InteliSys Gas

Gen-set controller for Gas application

SW version 2.4.0

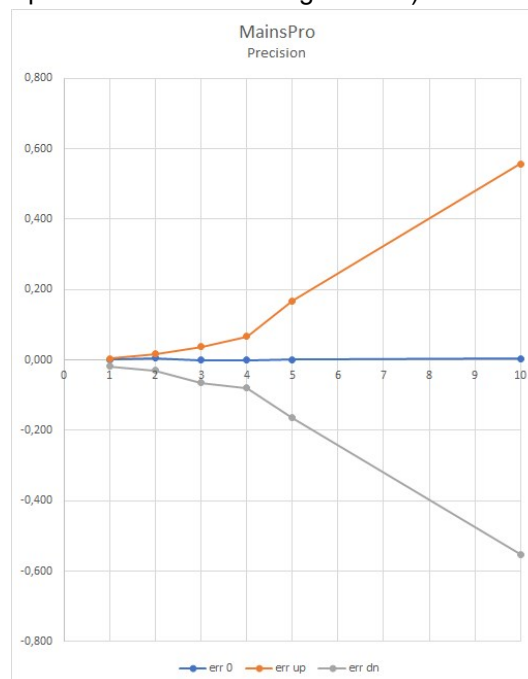
- RoCoF precision was degraded for higher signal values. Signal evaluation has better precision over the declared measuring range (example is shown on the image bellow)

- The RoCoF evaluates without spikes and signal evaluation has good precision over the declared measuring range.
